FLOOD INSURANCE STUDY
VILLAGE OF BELLE TERRE
SUFFOLK COUNTY, NEW YORK

Prepared by
HARRIS-TOUPS ASSOCIATES
Lake Success, New York

Request 371.18:

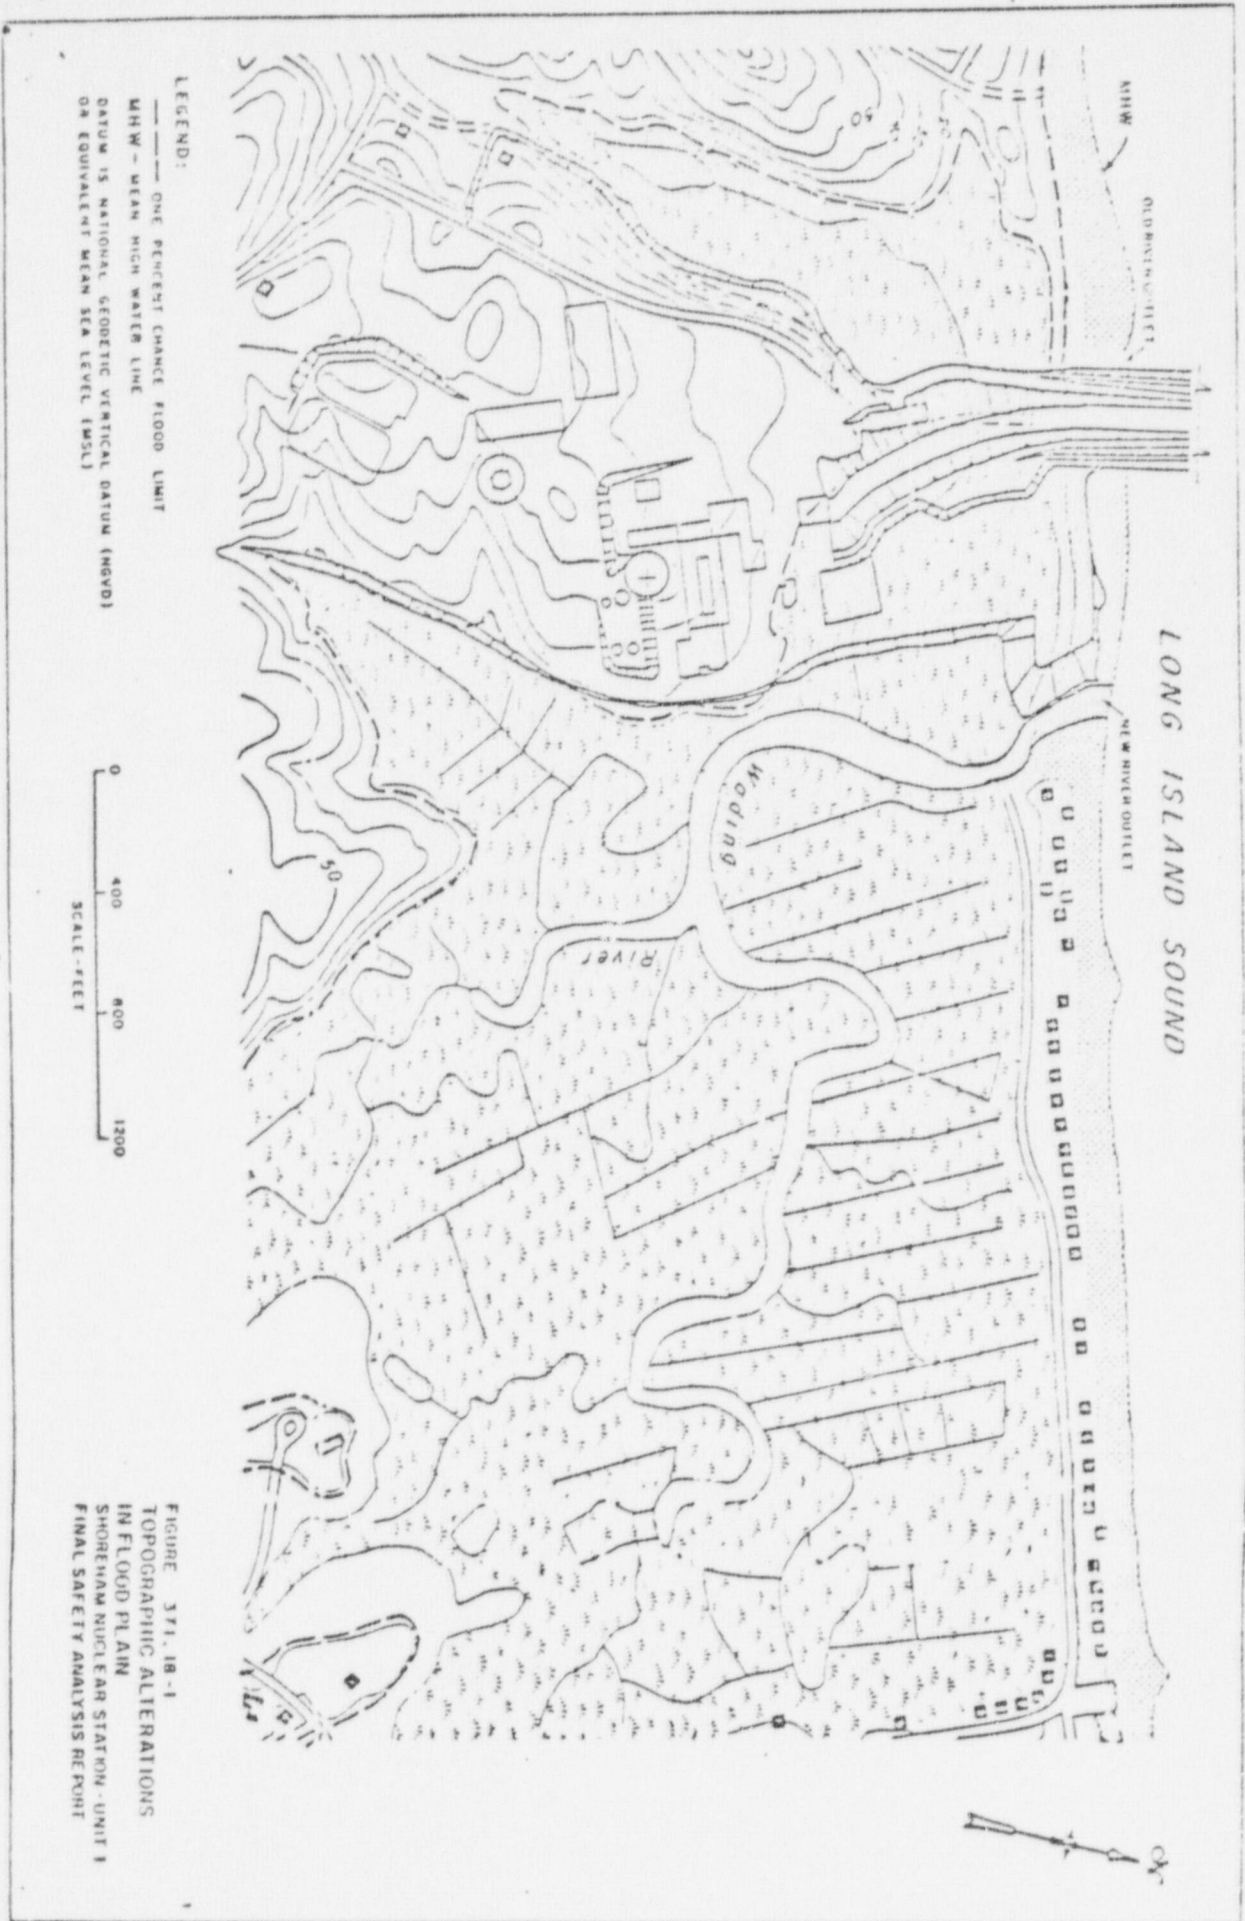
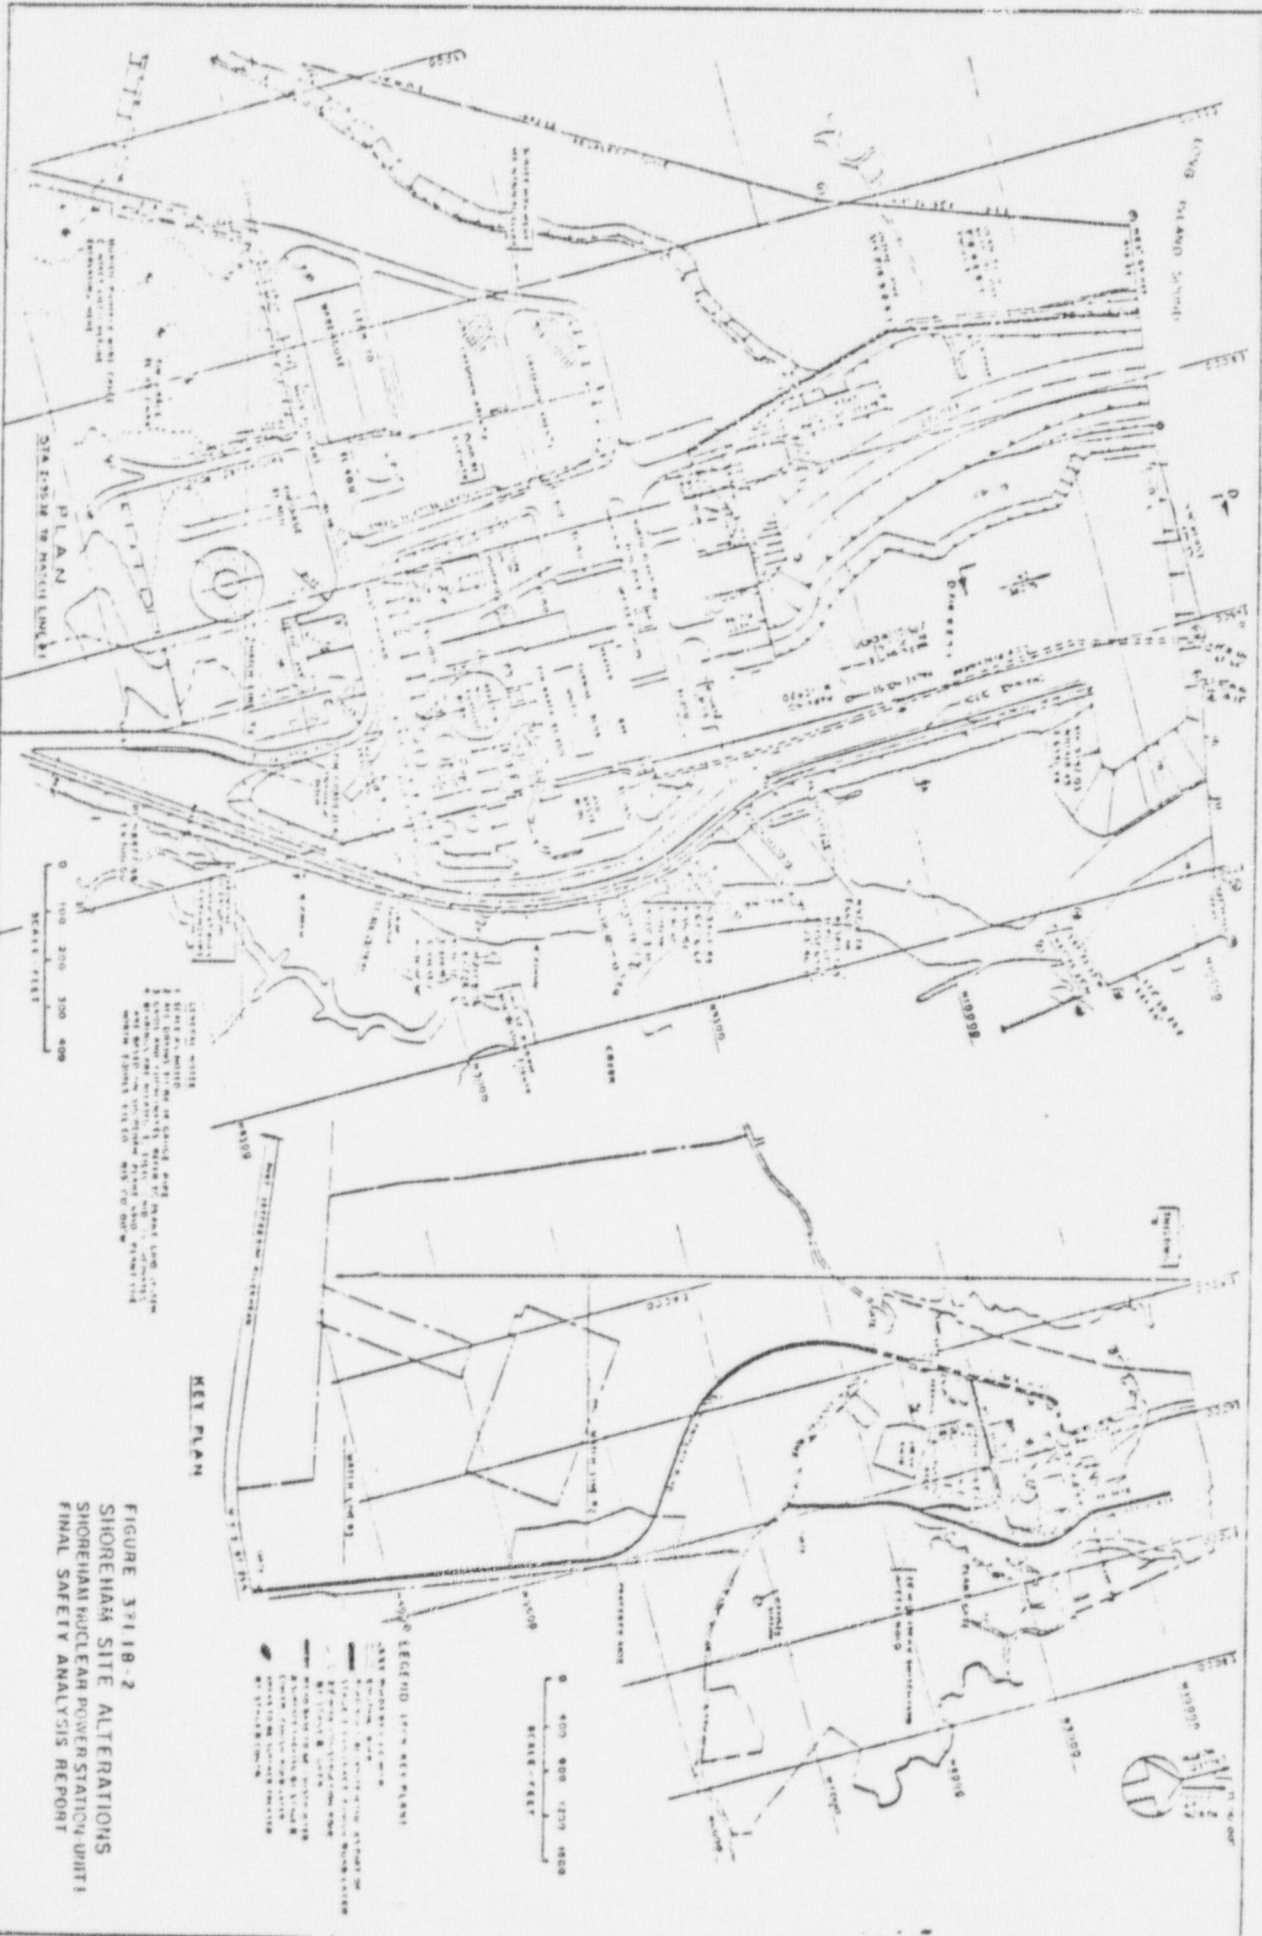
Identify, locate on a map, and describe all structures and topographic alterations in the floodplains.

Topographic alterations within the floodplain, as defined prior to construction, are as shown on Fig. 371.18-1. Identification of structures and details of site grade revisions are shown on Fig. 371.18-2.
